CASE SUMMARY • CONDITIONAL DISTRICT REZONING

City Council Legislative Hearing • April 7, 2026

Application to rezone ± 1.26 acres located at **4118 Market Street** from RB, Regional Business to MD-17(CD), High-density Multiple-dwelling Residential District (Conditional District) for a 76-unit multi-dwelling development. (Nicholas Silivanch, Applicant; Premier Hotels LLC, Owner).

Figure 2.1-A: Proposed Site Plan

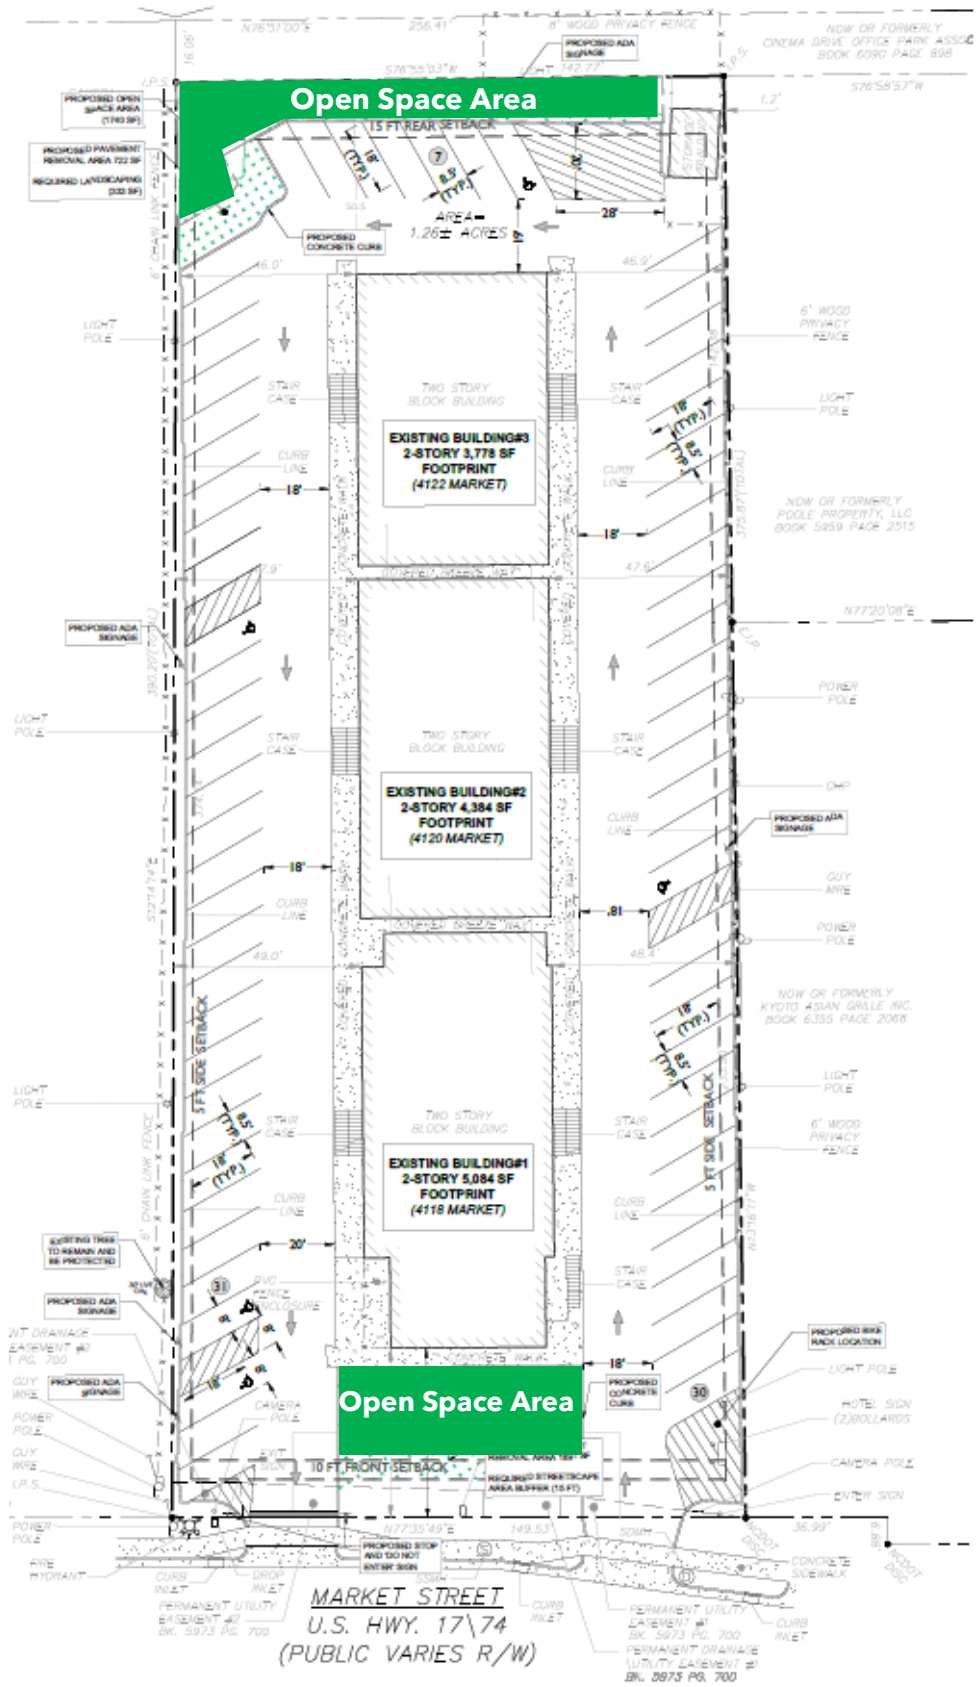
- The only physical change proposed to the site is the removal of the drop-off drive aisle that runs in front of the building. This section of asphalt would be replaced with open space; however, no specific plans regarding plantings or use of that open space area or the open space area shown along the rear property line have been provided by the applicant.

- While the proposal includes a workforce housing component, the proposal fails to offer any amenities or site enhancements for future residents.
- Staff believes the CDMU option permitted under the existing zoning is more appropriate as it would allow for the proposed density while also providing for a potential on-site commercial component that could provide services to residents.
